NOTICE TO ALL CONTRACTORS:

Proposal #13: 2265-16-70, WISC 2015 006
27th Street, City of Franklin/Oak Creek
W Drexel Ave to College Ave (CTH ZZ)
STH 241
Milwaukee County

This is Addendum No. 2, which provides for the following:

Addendum No.2
ID 2265-16-70
Revised Sheet 3
February 6, 2015

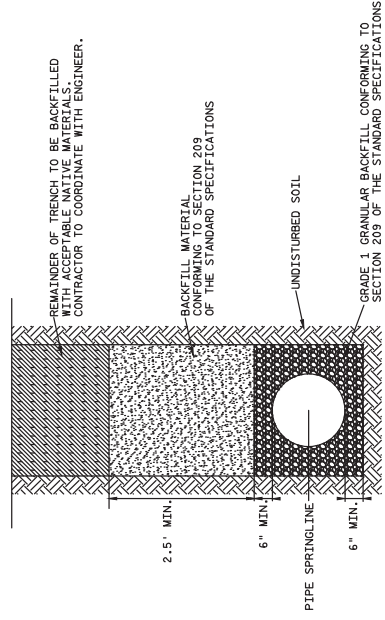
Revised Plan Sheets	
Plan Sheet	Plan Sheet Title (brief description of changes to sheet)
3	Remove a note from the general notes page.
51	Add a detail for Removing Storm Sewer items.
